**RE: Response Letter**  
**61 John Vertente Boulevard – New Bedford, MA**  
**SE 049-0791**

# **STORMWATER MANAGEMENT REPORT AND NARRATIVE**

**61 John Vertente Boulevard (Map 133 Lot 47)  
New Bedford, Massachusetts 02745**

PRE-DEVELOPMENT  
MAP  
SHEET 3A OF 5

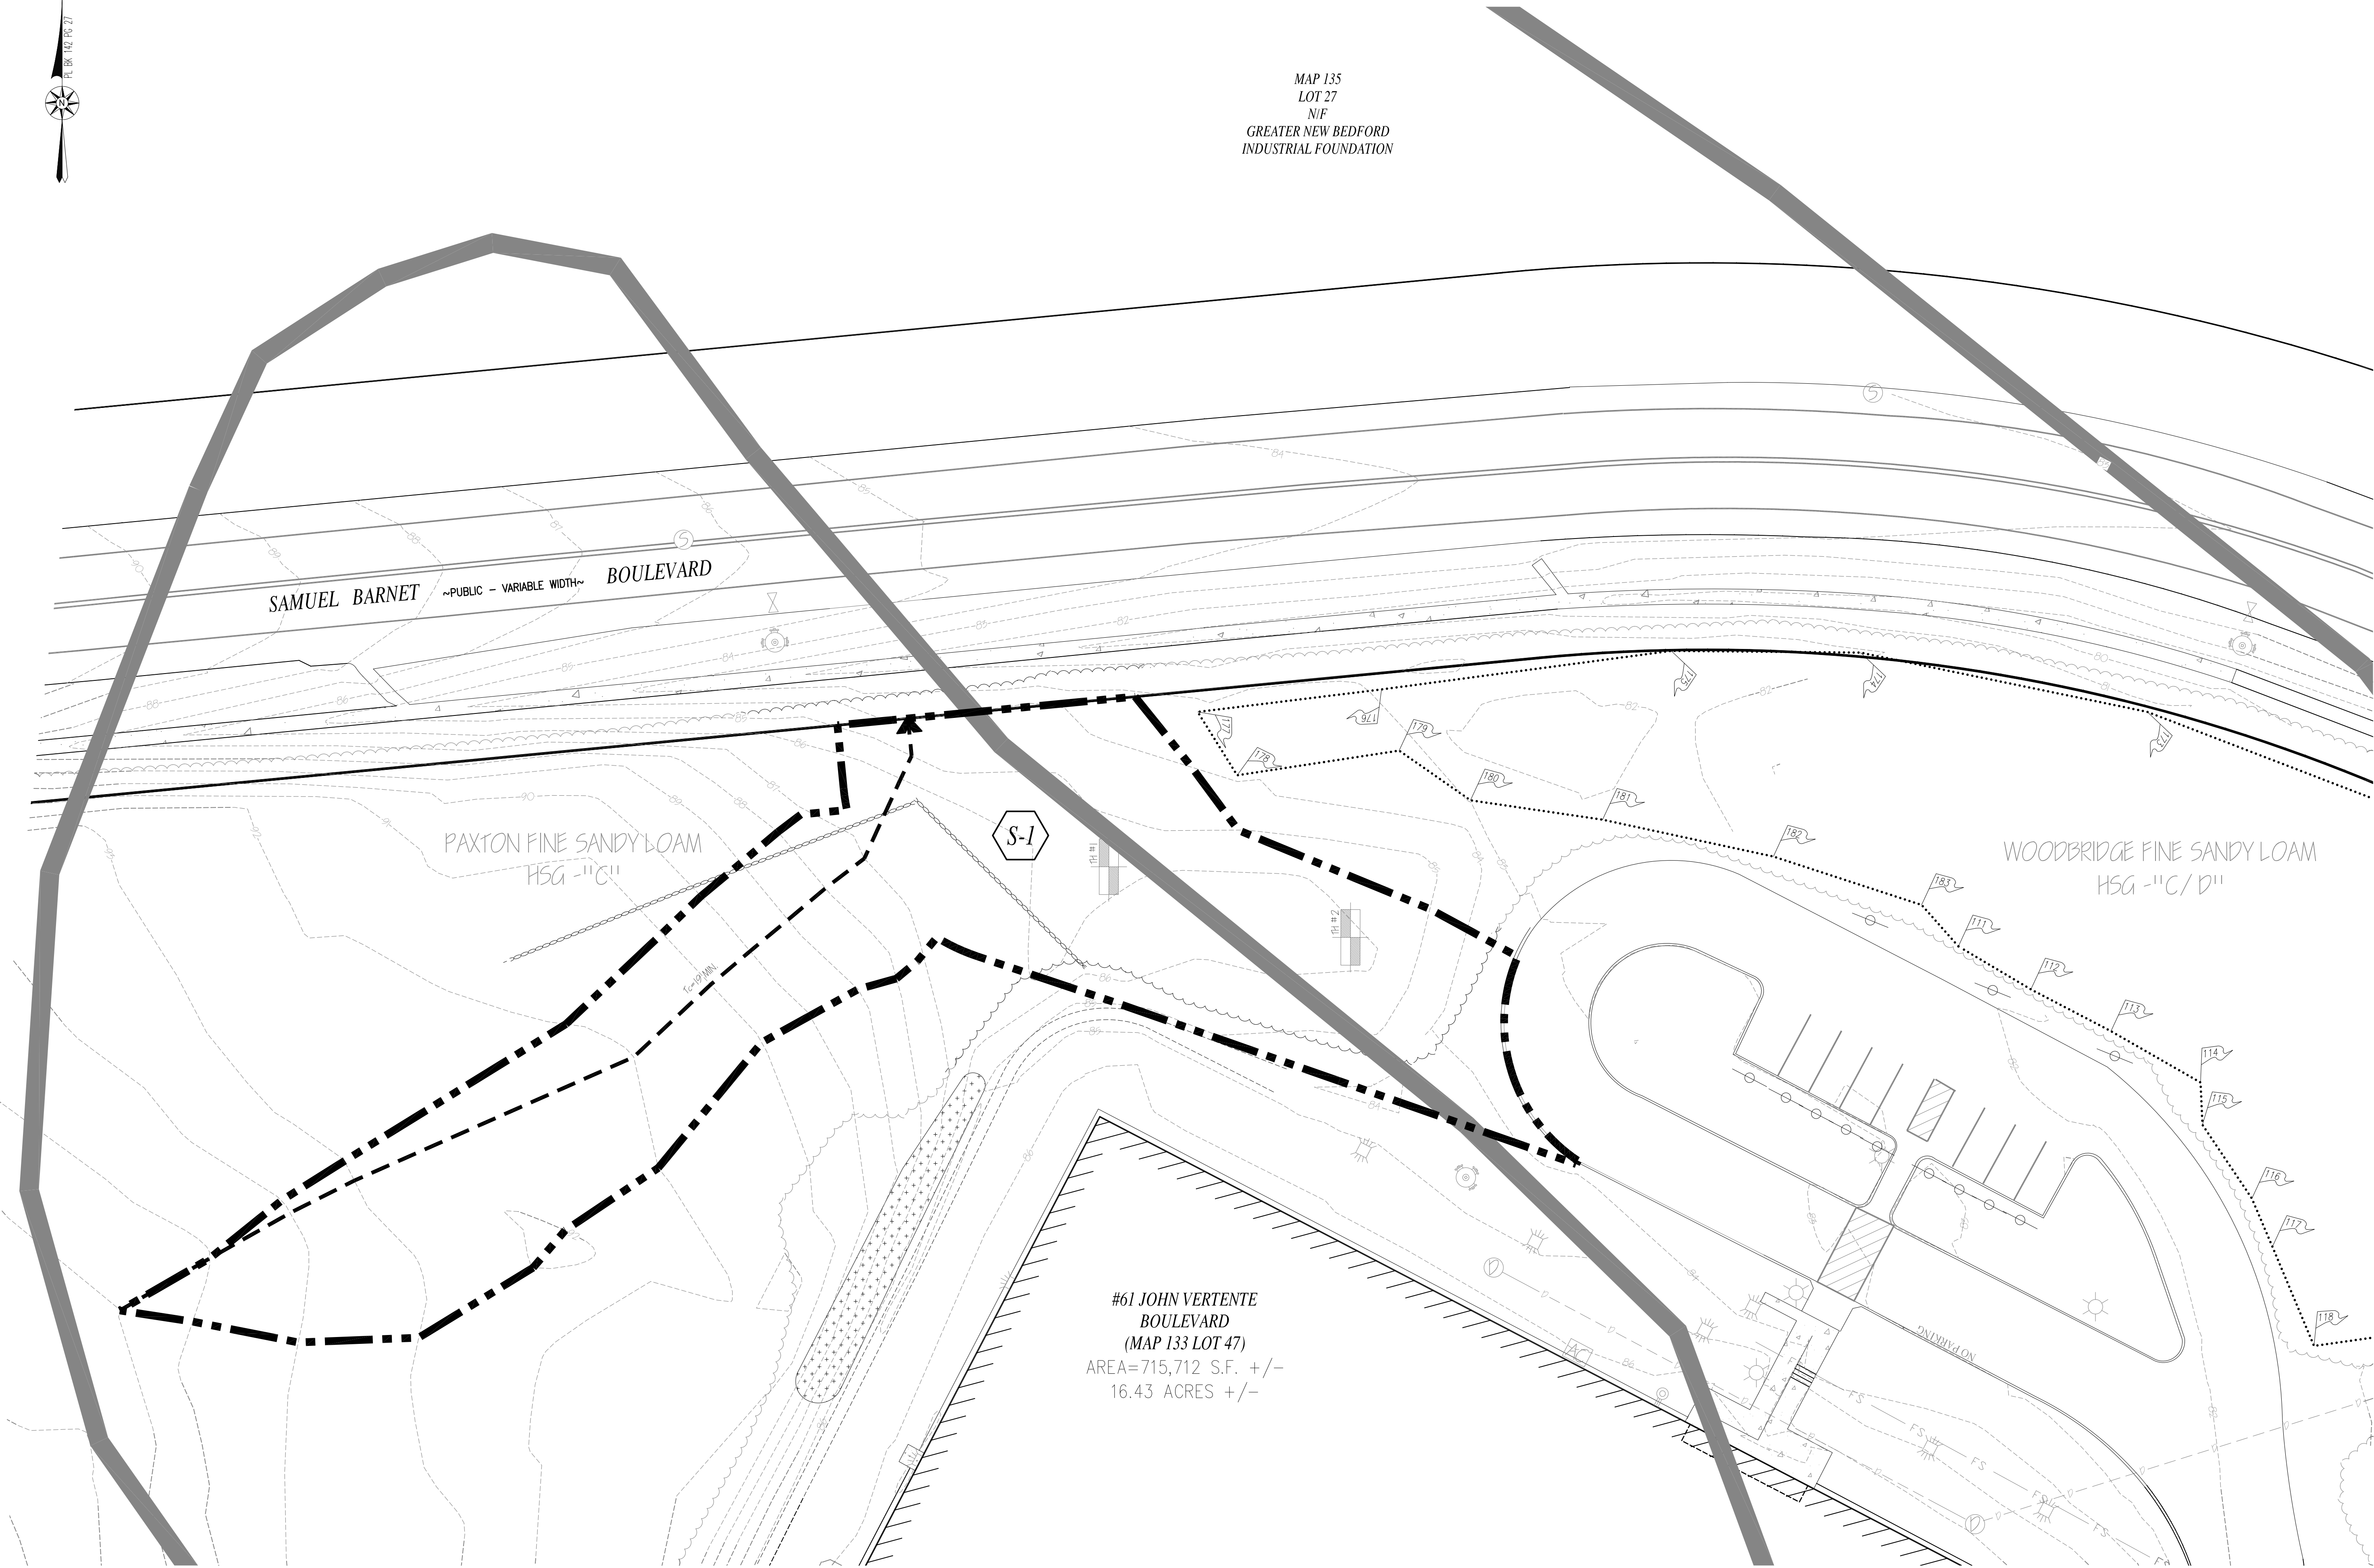
*With regards to the drainage areas draining to the rain garden, based on the swales you sketched it appears that a significant portion of the upland area will still drain to the driveway and then the rain garden. It also looks like that water that I diverted to the east will be captured in low point, which doesn't seem very desirable.*

**As requested, the HydroCAD calculations and drainage maps have been revised to incorporate this additional drainage area into the site conditions. Also, the proposed grading has been revised to facilitate the proper flow of stormwater to the designed discharge points.**

### RAIN GARDEN (PROFILE)

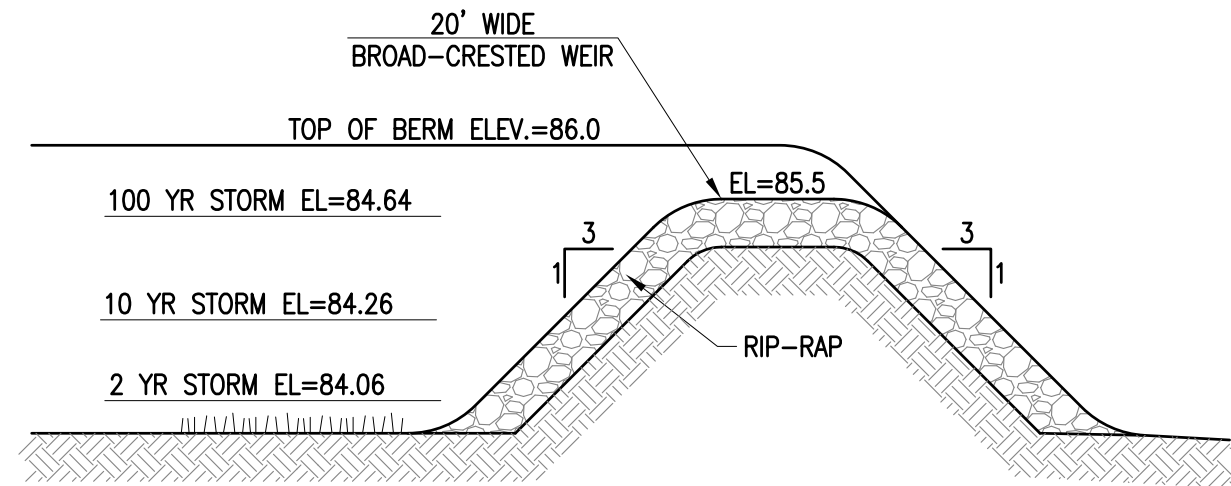
*With regards to the depths of the soil media and separation from groundwater, those are decisions that are left to the Commission. My job, as consultant to the Commission, is to point out where projects are inconsistent with the Standards and let them make the decisions about whether or not to approve projects. You are asking for 'waivers' from these Standards, so as long as your design is inconsistent with the Standards I will keep it in front of the Commission.*

*With regards to the rain garden detail, your elevations on the detail shows a bottom elevation 85 and the plan shows 84.*

**Farland Corp. requests that as a special condition to the project, the Commission consider splitting the difference between the required planting soil media and the required groundwater separation. This has been represented in the revised Details Plan (Sheet 4).**

**The plans and details have been revised to show consistency.**
